Loddon Garden Village - South

DESIGN RESPONSE

Prepared by:	Chris Shaw
Authorised by:	Leigh Abley
Date:	08 July 2025
Document Reference:	A392 – R066 LGV South RSA 2 Designers Response

Road Safety Audit – Loddon Garden Village South

Appendix B: Key Plans showing Audit Problems

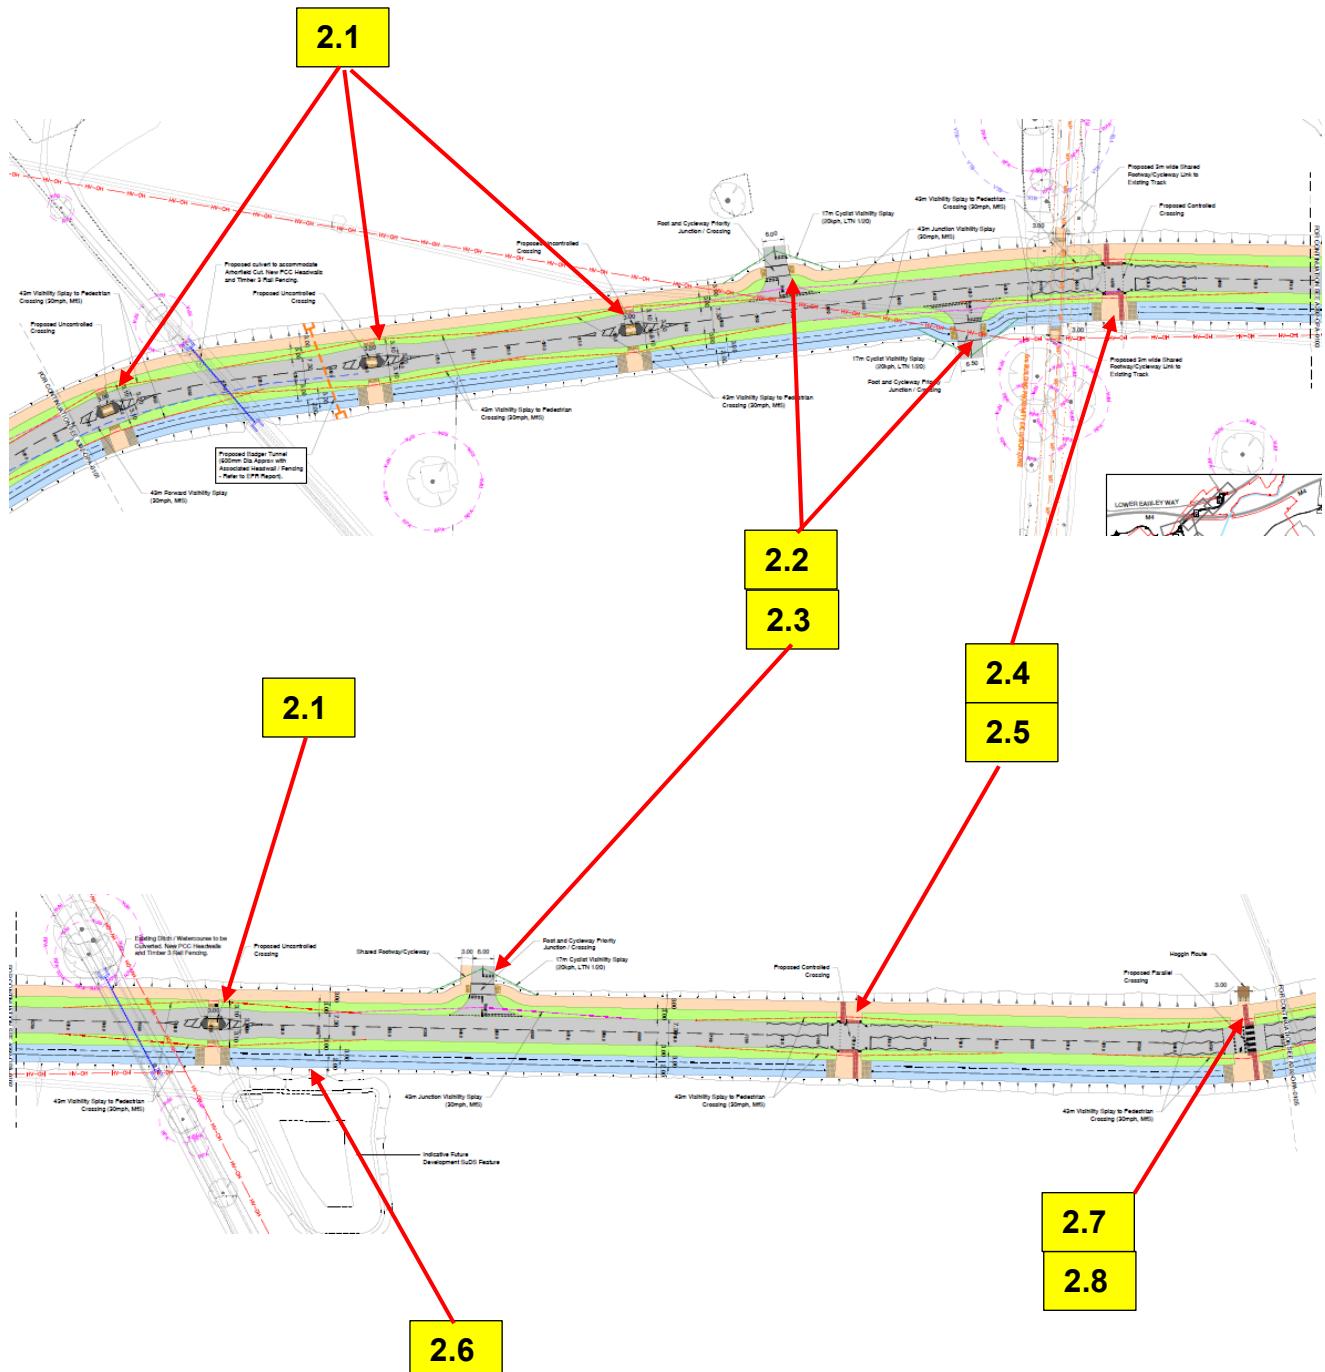
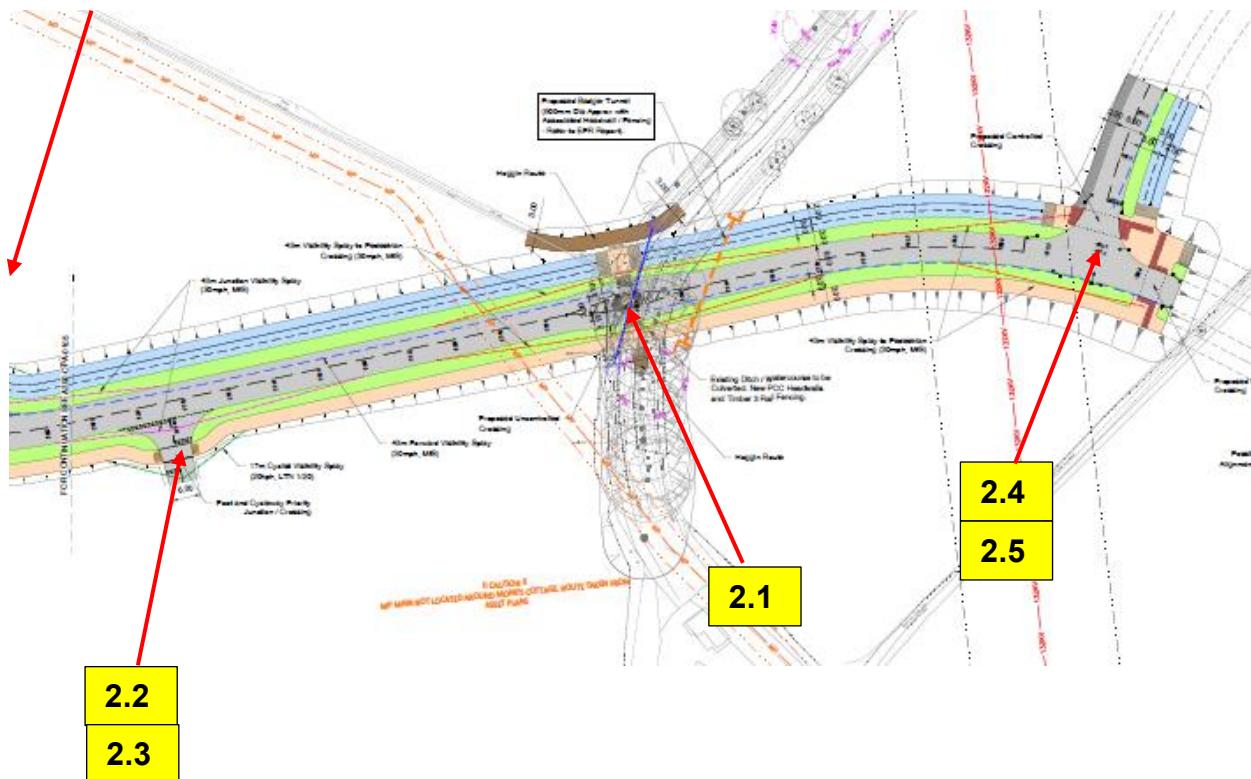
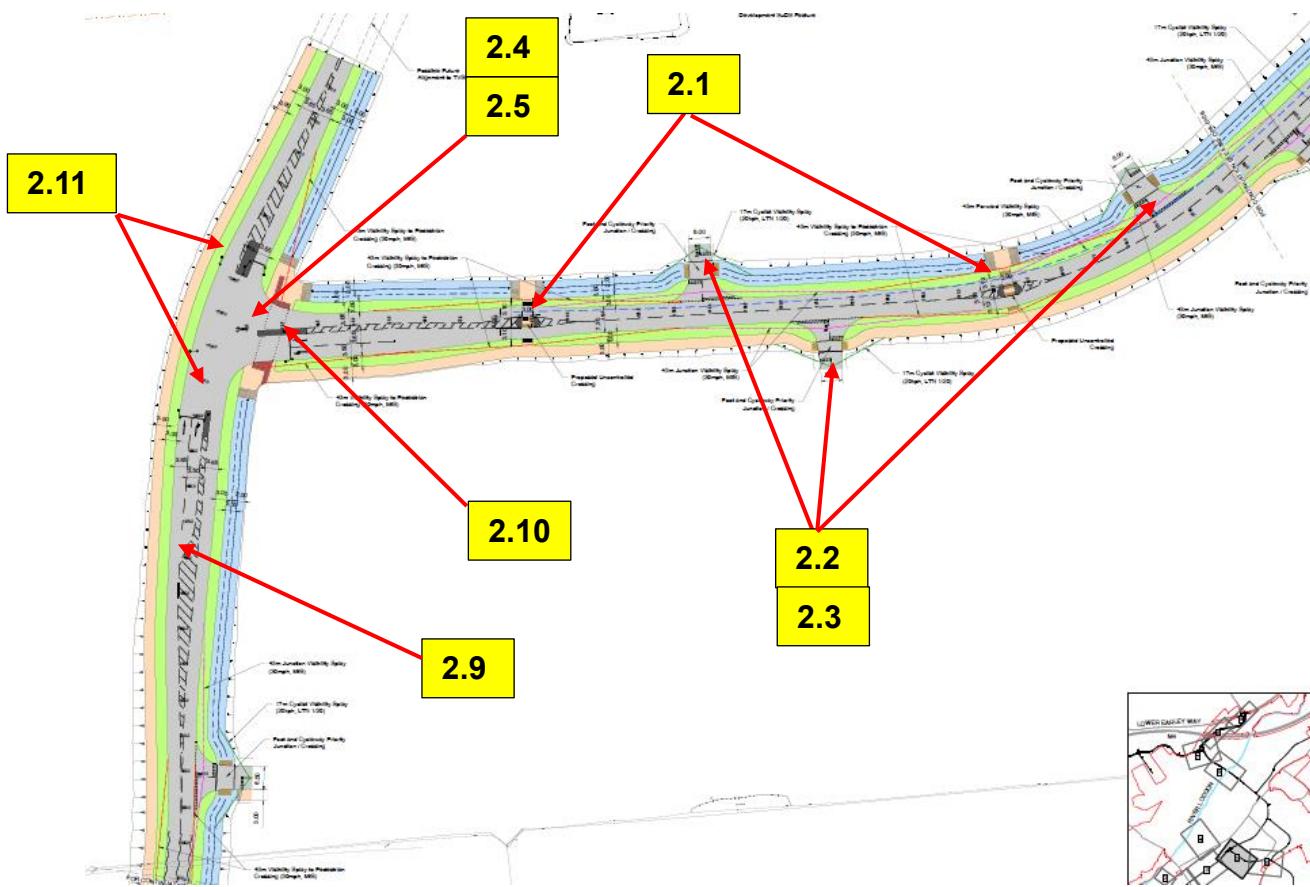
2. Safety Issues Raised in this Stage 2 Road Safety Audit. (see Appendix B for locations)
